SEWAGE DISPOSAL SYSTEM

DEPARTMENT OF HEALTH AND MENTAL HYGIENE

SUBDIVISION Green Hill Manor LOT 18 Sec. 4 ROAD 6686 Luster Drive

REPAIR - PURPOSE - In support of future building permit addition - increase in number of bedrooms.

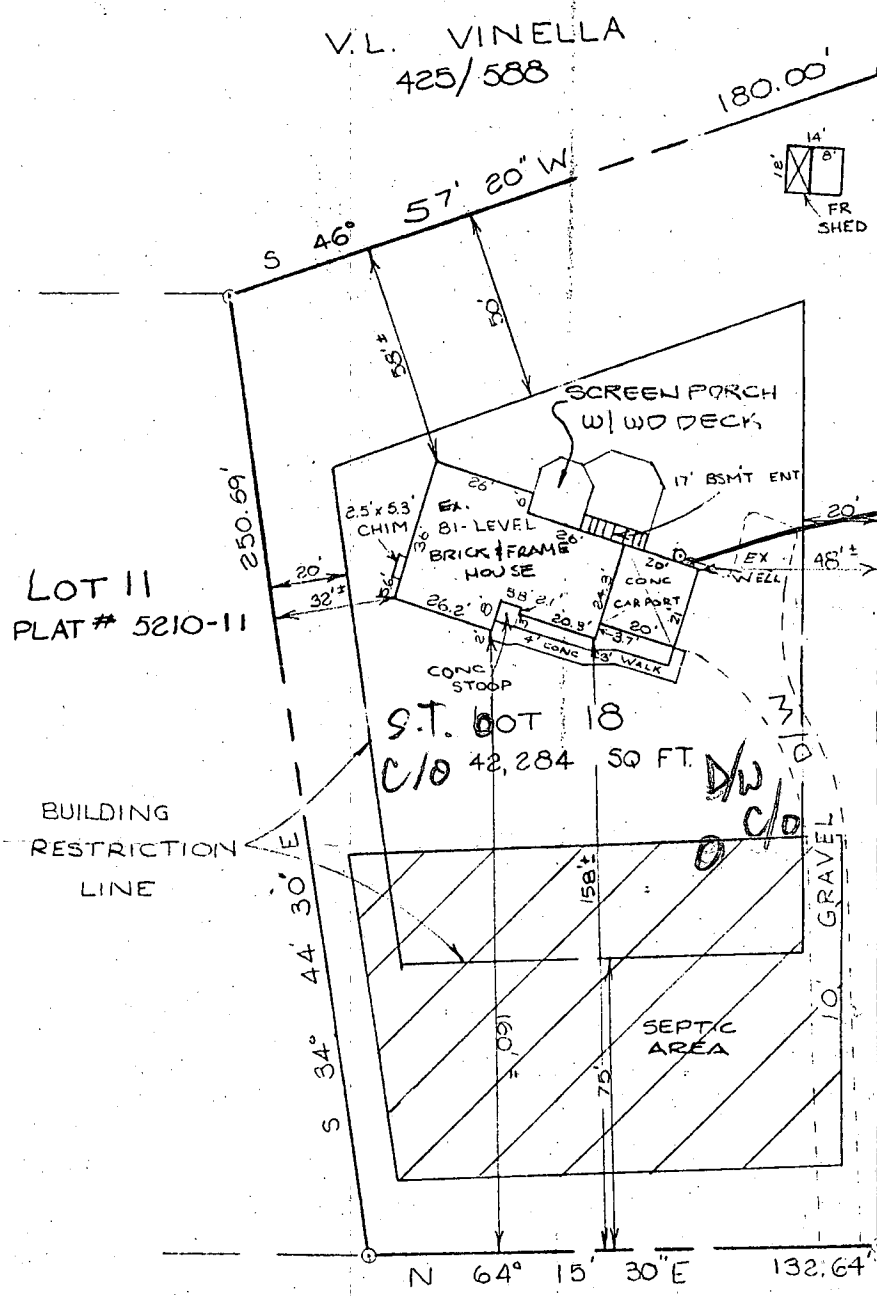
REMARKS: 8/22/95 #1 OK TO CONTINUE

8/22/95 PERMIT SHOULD HAVE STATED 5 BR. (EX. 4 + 1 NEW) SYSTEM COULD HAVE BEEN LARGER BUT ACCEPTABLE; OK TO COVER (FINAL GIVEN BY T/C) HR

EX. WELL (NOT AG)
IS 2.5' FROM
EDGE OF EX.
LOT 17 CARPORT

RECOMMEND
ELIMINATION OF
GARAGE FROM
PROPOSAL, 2ND FLR.
BR ADDITION
OK W/ REPAIR BY
FYOCK (IMMINENT
PER HOMEOWNER)

LUSTER DRIVE 8/16/95 MR
50' R/W BP ACCEPTED W/ GARAGE BY CW
8/22/95 OK TO SIGN MR

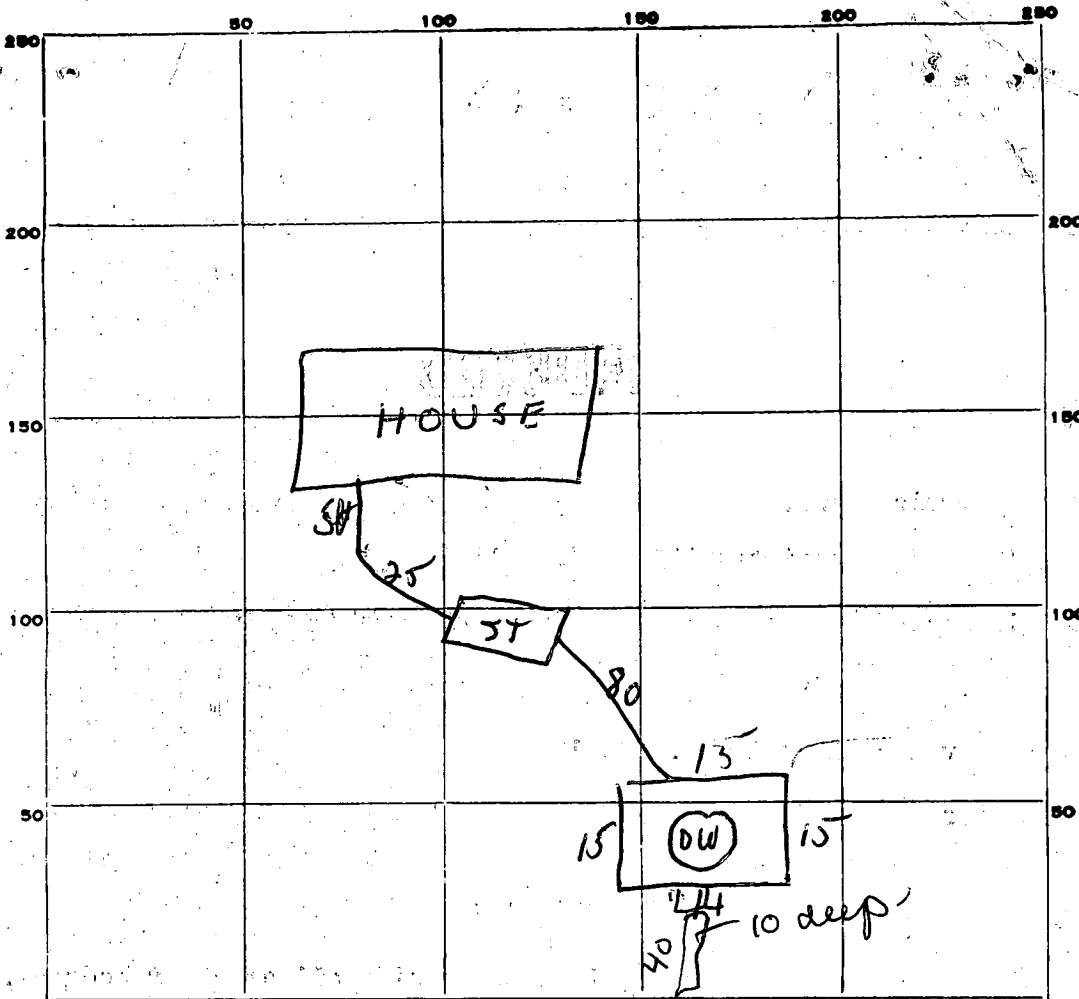
REMARKS Inlet 3ft below grade - needs trench off side after 5 ft earth buffer
trench to be 10ft deep - 40 ft long - 5 ft stone: to call for map
of trench before gravel is installed

11/17/78 STONE ADDED TO DITCH AREA
575 SQ FT TOTAL

~ PROPERTY OF ~
 MR & MRS. LEE S. BROWN, JR.
 GREENHILL MANOR SECT 4
 FIFTH ELECT DISTRICT
 HOWARD CO. MD

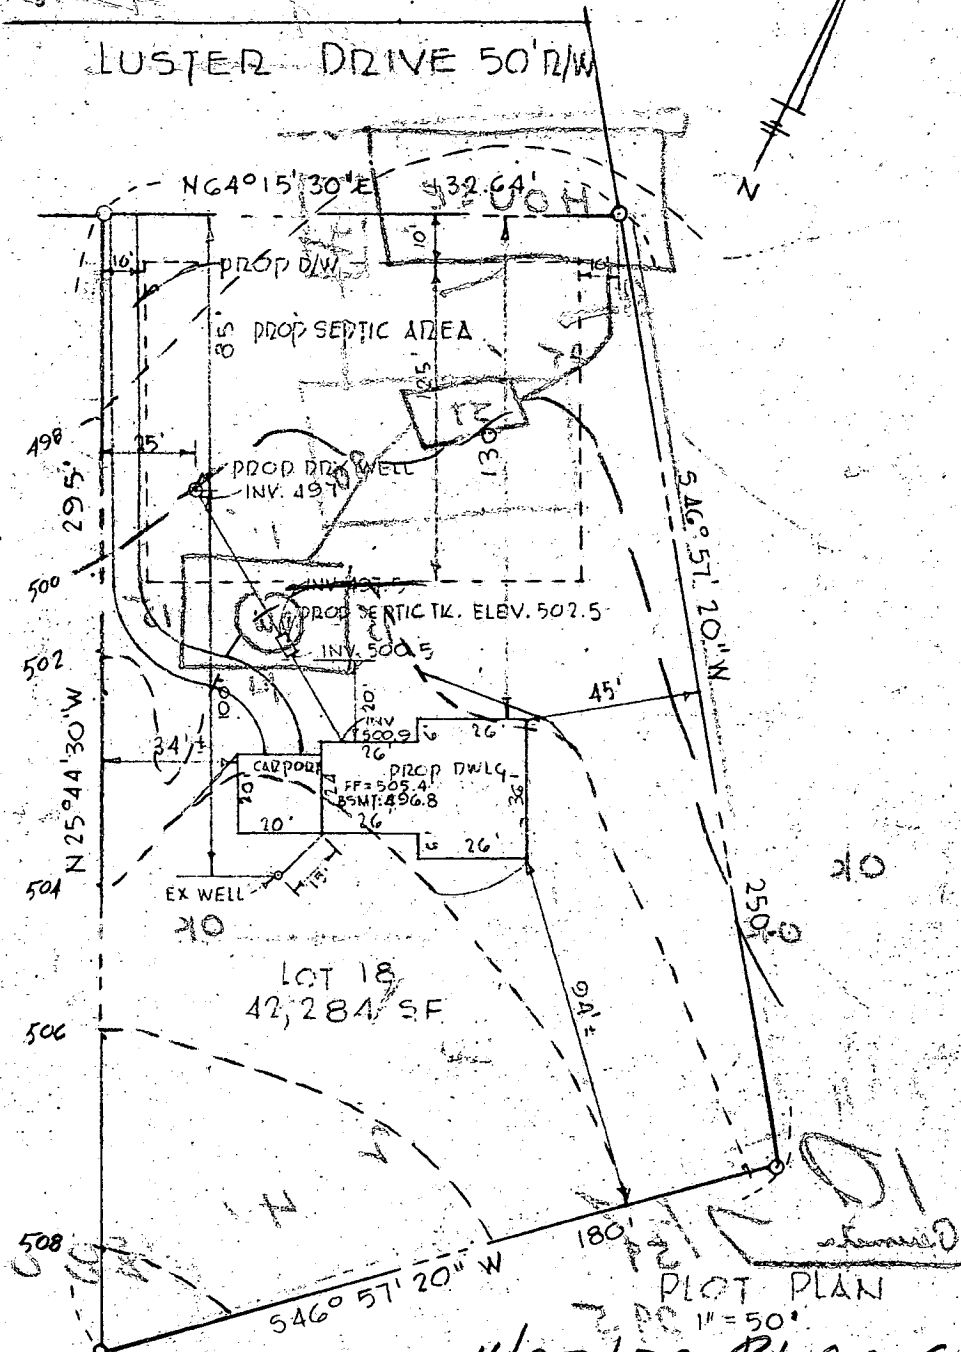
4/27/78 PLANS
 REVISED OVER PHONE
 & NOW OK R/A
